Interactive comment on “The hydrological cycle in the high Pamir Mountains: how temperature and seasonal precipitation distribution influence stream flow in the Gunt catchment, Tajikistan” by E. Pohl et al.

E. Pohl et al.

Reply to C618:

Fig. 1. Changed colours for elevation ranges of Fig.1

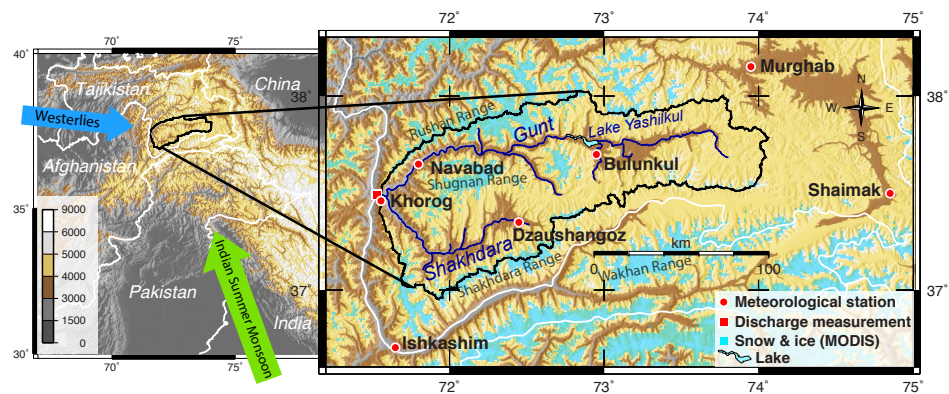
(C659-22) Figure 1. Please use color scale for elevation. It is difficult to see elevation in gray scale.

We agree and coloured the elevation ranges of 3000-4000 and 4000-5000 m a.s.l. in colours to make it easier to discriminate the different elevations.

Fig. 2. Added ratios for individual sites Navabad and Bulunkul in Fig.3

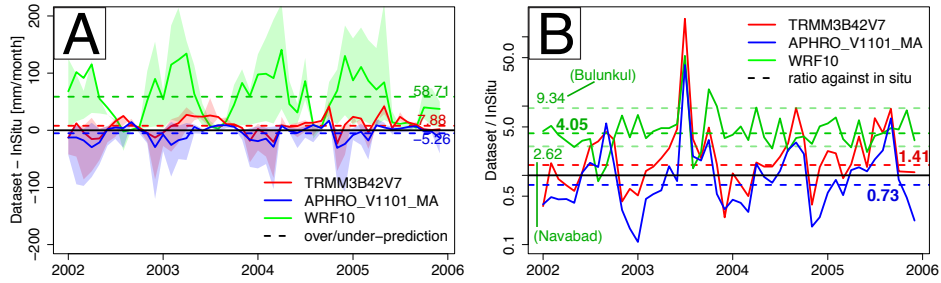
(C659-13) Page 1169, Line 11. "Correction factors" were applied to precipitation data to match the model results with observed discharge. The correction factor of 1.5 indicates a 50% increase in precipitation. It is hard to justify such a major adjustment of precipitation input. A much more careful consideration should be given to manipulation of precipitation data.

We start by addressing quality issues of in situ data, where only site Navabad is equipped with an automatic precipitation sampler and is assumed to have the highest standards. The already mentioned possible orographic effect, i.e. orographic shielding from precipitation, that affects site Bulunkul might also be apparent at other sites due to the coarse (10km) dataset grid size and the location of meteorological stations in valleys. We address this issue and provide additional information in particular in Fig.3. The adjustment of Fig.3, which still shows the relationship of all data of all pixels encompassing meteorological stations, now includes the resulting ratios of the two individual stations Navabad and Bulunkul. As we used the mean of all stations to derive the "overestimation-ratio" of HAR10, this extended analysis shows how strongly this ratio is affected by individual sites. Bulunkul e.g. shows a 9.3-fold overestimation. Navabad on the other hand shows a 2.6-fold overestimation.

The different obtained ratios are now also addressed in Table 3 to show not only the correction factors for precipitation of HAR10 after downscaling (dividing by 4.05), but to show the overall factor if the original dataset had not been downscaled in a first step. In fact the applied factor of 1.5 after downscaling to obtain a ratio with in situ data of unity (resulting in HAR10 (258mm)) corresponds to $1/4 * 1.5 = 0.375$ (or $1/2.7$). These actual factors that are applied to the original HAR10 dataset are now included

in Table 3. In the end, the applied factor that leads to the best model results ($1/4 * 1.5$) corresponds to a 2.7-fold overestimation of HAR10 that is close to the 2.6-fold overestimation resulting from the exclusive comparison of the site Navabad pixel and its in situ data.

Fig. 3. Added temperature in Fig.7

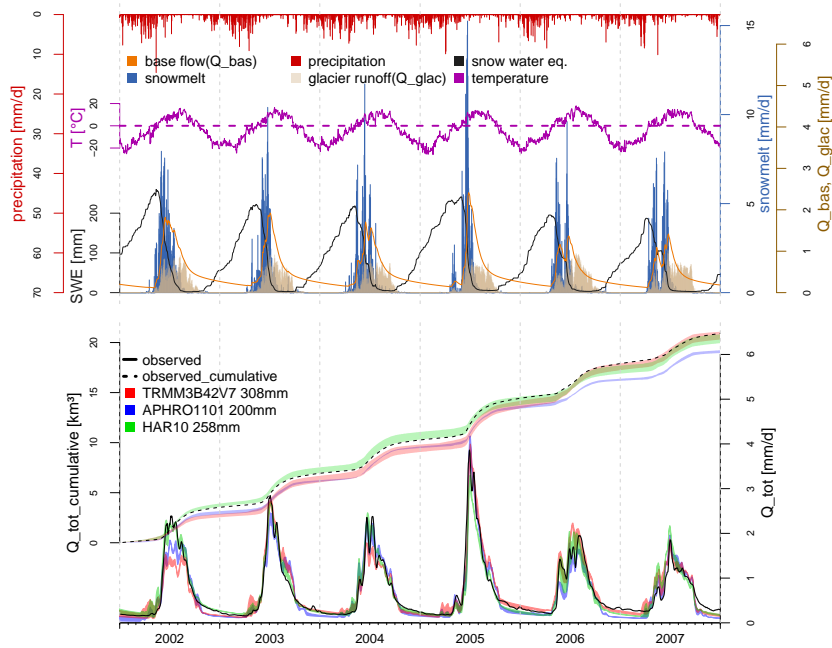
(C659-23) Figure 7. Simulated discharge curves appear to be smaller than observed in 2002. Was the spin-up period long enough to equilibrate the storage?

(C659-23) The small discharge is simply resulting from low precipitation amounts for TRMM and APHRODITE datasets. The models with HAR10 actually show a good match of simulated and observed discharge. Hence, we are confident that the spin-up period was long enough.

Fig. 4. Additional figure to display average annual hydrological components on a monthly scale

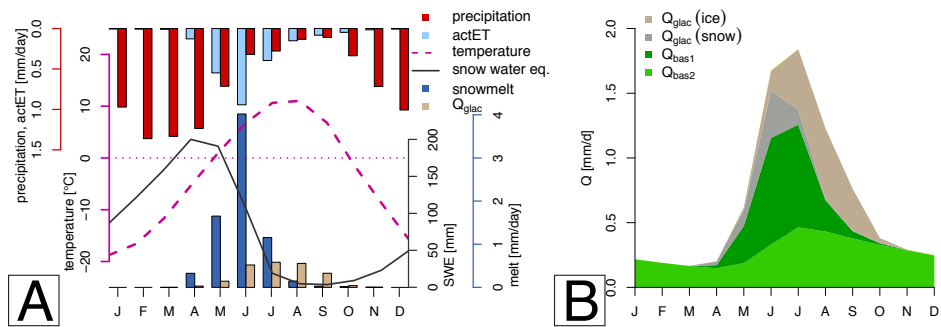
(C618-20) In section 7.1 hydrological cycle, one expect a detailed discussion on various components of the hydrological cycle of the catchment including basin average precipitation synthesised through the modelling effort, discussion on 30% glacier contribution as mentioned in the abstract and conclusion and actual evapotranspiration and runoff etc.

(C618-20) We agree and now discuss single components of the hydrological cycle on the basis of the provided additional figure in more depth.

Fig. 5. Additional figure for appendix to show monthly relative humidity in 2004 for 3 sites compared to averaged monthly values obtained by the model for the same year

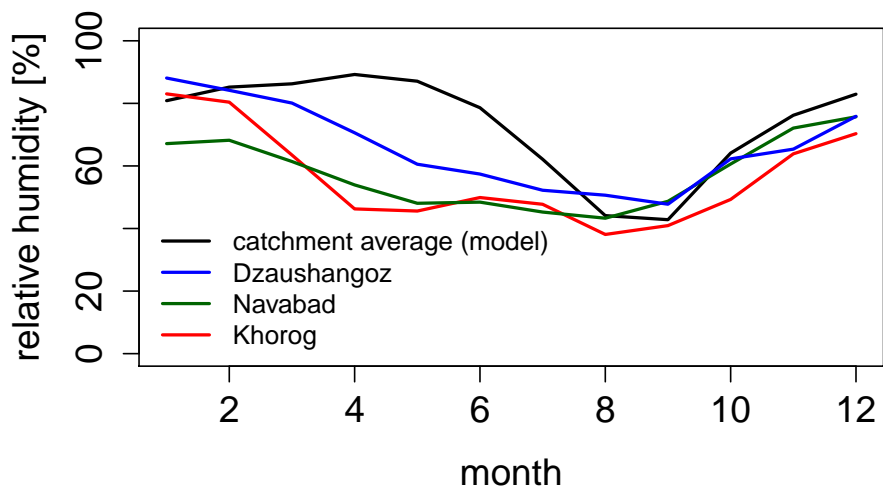
(C659-15) Page 1173, Line 25. Were there any attempts to validate wind speed and relative humidity data? One short season of field campaign will provide a valuable opportunity to examine the data reliability and uncertainty.

(C659-15) We gathered additional monthly relative humidity data for single years of three stations and provide them in an additional diagram. Except for late spring/early summer the curves reasonably match. We assume the mismatch to result from the already depleted snow cover at the station locations (at valley floors) contrasting a still partially snow covered catchment (average elevation of the catchment is above the elevation of meteorological stations). Our assumption is here supported by the additionally provided figure on snow cover (from the reply to C594). We were not able to obtain additional wind speed data.
